**CONVENTIONAL (NON-ENGINEERED)
 ON-SITE WASTEWATER TREATMENT SYSTEM (OWTS) DESIGN WORKSHEET
 (MUST BE COMPLETED FOR ALL CONVENTIONAL DESIGNS)**

0036528
EL PASO COUNTY HEALTH DEPARTMENT
COLORADO SPRINGS, COLORADO
DISPOSAL INSPECTION FORM

Septic Permit Updated_V1.pdf Markup Summary

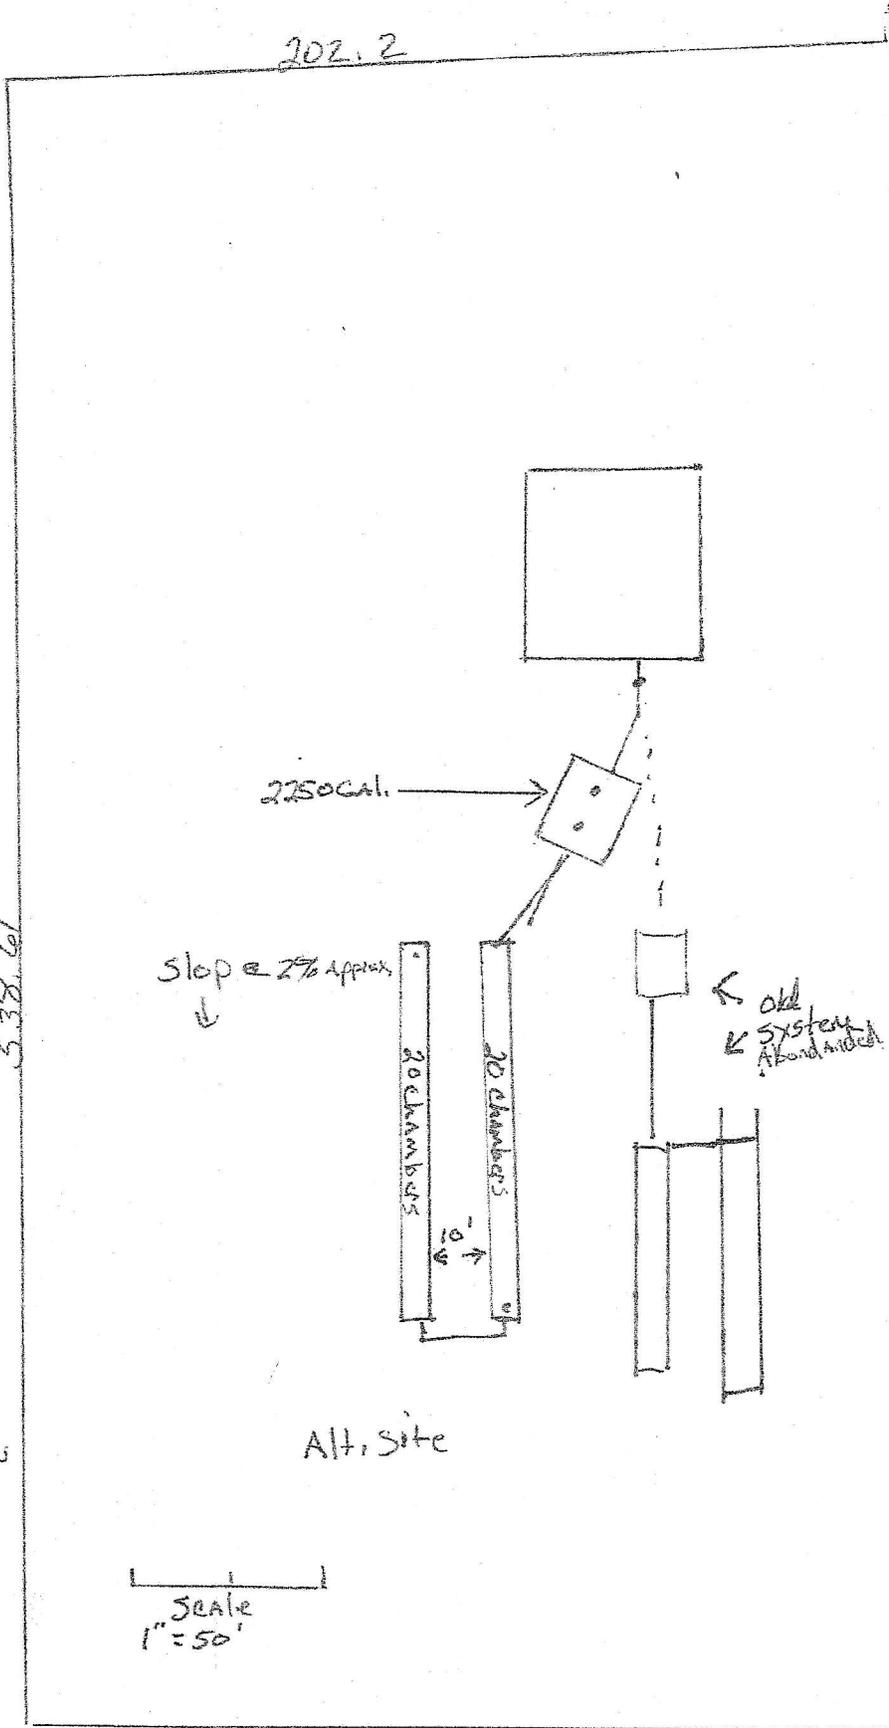
It appears that this is the original septic permit from '82 for the existing 6-bedroom house. This will serve as a placeholder for now if an updated septic permit is not attainable at this stage/prior to this special use approval. Please note, however, that an updated septic permit will be required either prior to approval of this project, or prior to building permit issuance as a conditional of approval for this project.
